Products: Smoke Extractor Actuator
Serial Range: N/A
Release Date: May 30, 2023

Smoke Extractor Actuator

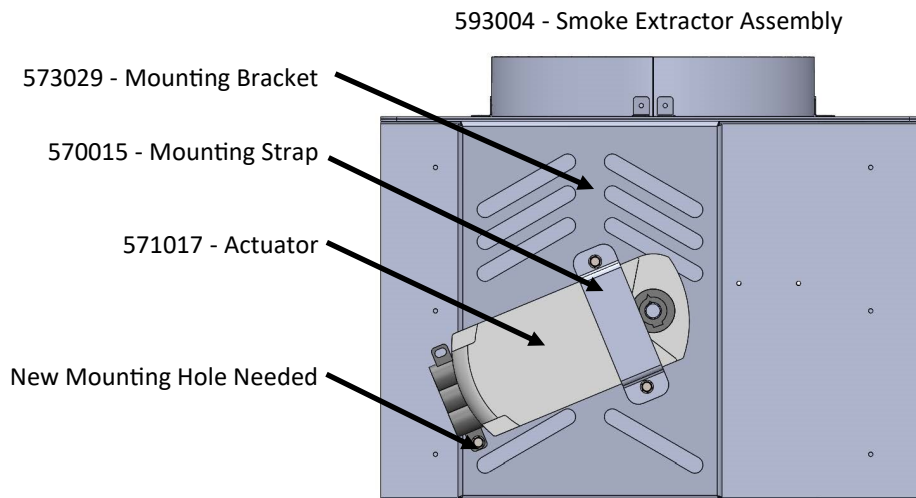
The current smoke extractor actuator for single-damper smoke extractors (571003) has been discontinued by the manufacturer. It will be replaced with a similar actuator from the same manufacturer. The new actuator (571017) is slightly larger and will require a new mounting strap. The new mounting strap (570015) attaches to the mounting bracket using the existing holes. The third mounting hole for the actuator is in a different location. A new hole can be drilled in the existing bracket, or a new bracket (573029) can be purchased. The same conduit connections and adaptors are used.
